# M3

550cc

PrintArea

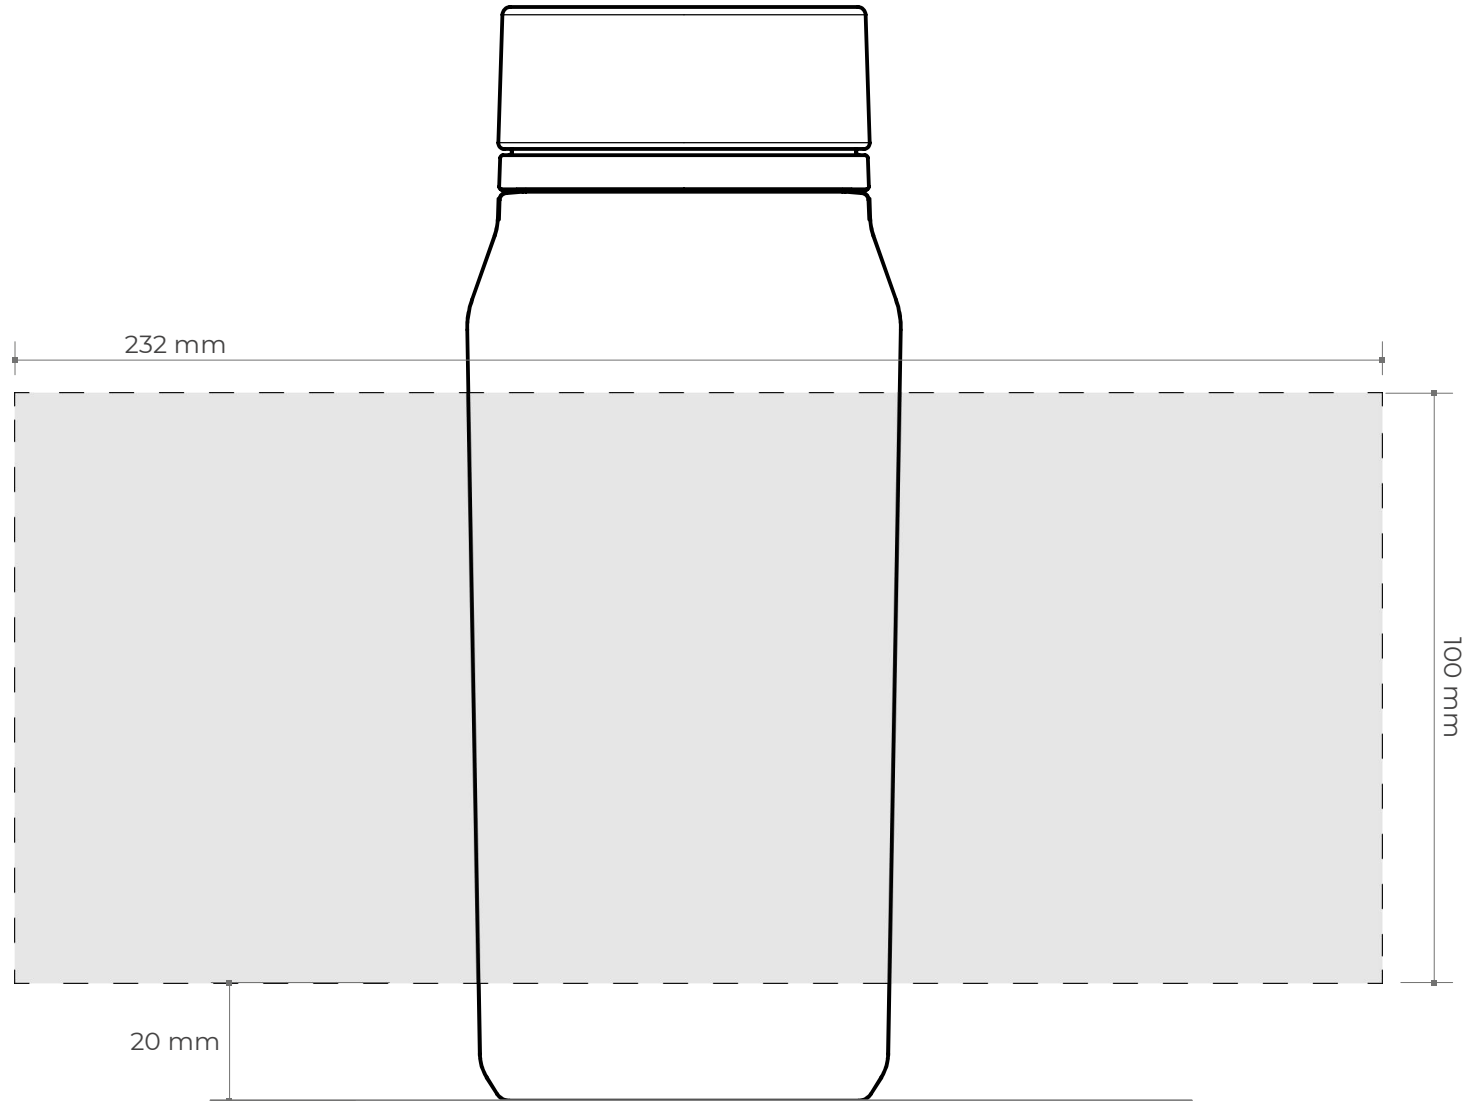
*The impression can not close on the circumference of the bottle:  
it's necessary to consider a non-printable area (approx. 0,8 cm width)*
